Subdivision and Land Development Cover
Page for SLD # 06-24

Project Name:
Germantown Pike Twins

**RE: SLD#06-24 / 604-608 Germantown Pike
Proposed 20-Unit Twin Home Development (Sketch Plan)
Zoning Ordinance Compliance Review Letter**

Reference: Sketch Plan Review
604, 606, 608 Germantown Pike
Whitemarsh Township, Montgomery County, Pennsylvania
SLD #06-24

Attachment B: Reduced Copy of Applicant's Proposed Site Plan

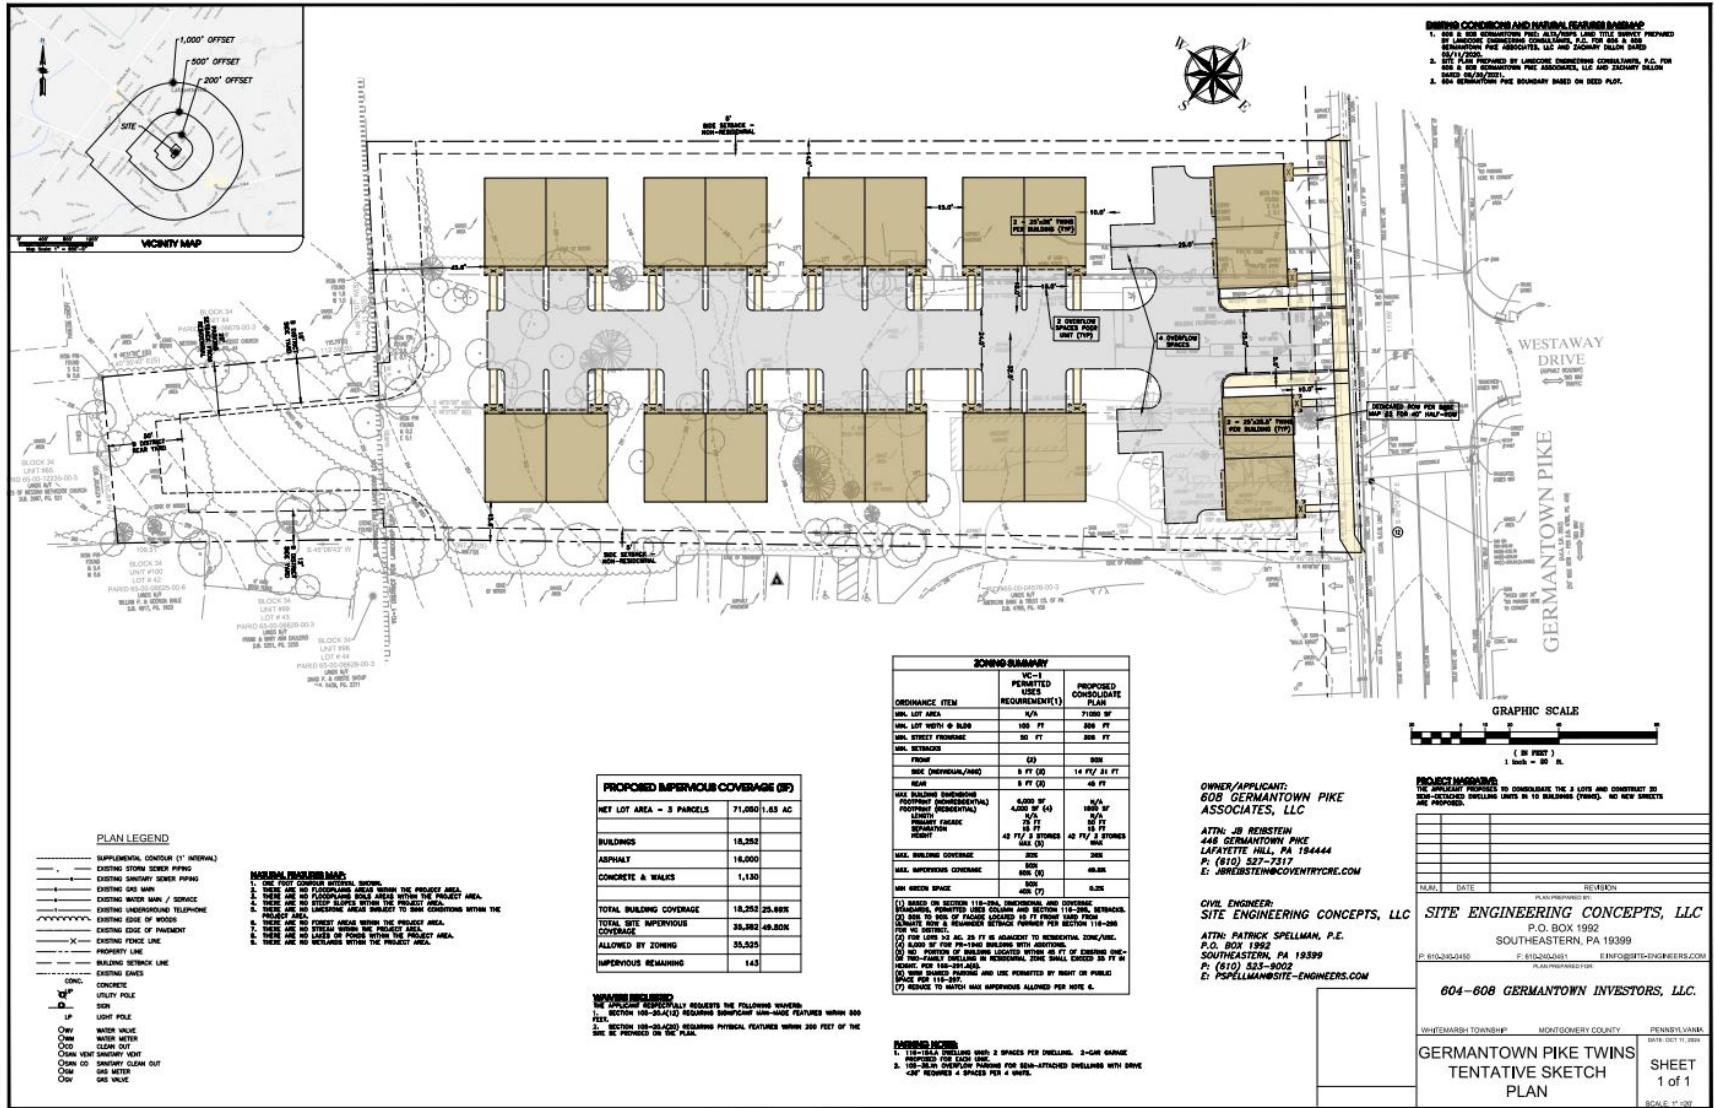
The site development has a single means of ingress/egress from Germantown Pike along a 24 ft. wide street (+/- 345 ft. in length), which ends in a short 7’ stub which is an inadequate configuration for a vehicular turn-around. The short stub is also placed at the ends of both driveways behind the twins that front Germantown Pike. The plan should provide a designated space for a vehicular turn-around in these locations that is an acceptable configuration to the township.

The sketch plan does not provide the needed sidewalks along the street to ensure that pedestrians have a safe, accessible route to Germantown Pike from the interior of the development. Walkability and connectivity in the redevelopment of this area are important considerations and are identified as goals in the township's *Selective Comprehensive Plan Update, Nov. 2020* and in the *VC- District's Legislative Intent*(Section 116-288.H.).

The proposed street is 24 ft. wide and will not provide adequate space for a pedestrian and two cars in the street. One of the goals of VC-District's legislative goals according to Section 116-228.H, " (is to) . . . Encourage bicycle and pedestrian accessible development, reflecting a village center rather than (an) auto-oriented commercial site development ". We recommend the applicant provide safe accessible space for pedestrians to walk in the development. If an increase in impervious coverage is a concern, we recommend that Flexi-Pave pervious paving be considered as a sidewalk material.

The applicant's plan does not show the required crosswalk improvements on both the north and south side of the intersection at Germantown Pike and Westway Drive. We believe that cross-walks should be provided at this location. The need for crosswalks in the VC-1 District is further demonstrated by the township's *Selective Comprehensive Plan Update, 2020* which advocates for the township to "develop and implement a 'Complete Streets' policy" for the township. (Policy #2).

The sketch plan does not illustrate where on the site the minimum vegetated open space area is provided and how the required *Minimum Vegetated Open Space* is addressed. (§ 116-294.9). We recommend the township evaluate the sketch plan's green area and encourage the applicant to include a designated area for outdoor enjoyment and potential passive recreation for the residents.

The submitted sketch plan does not indicate where the stormwater management facilities will be located within the development tract. The township should ensure that this area is shown and discussed, and ensure this is an effective solution for stormwater management.
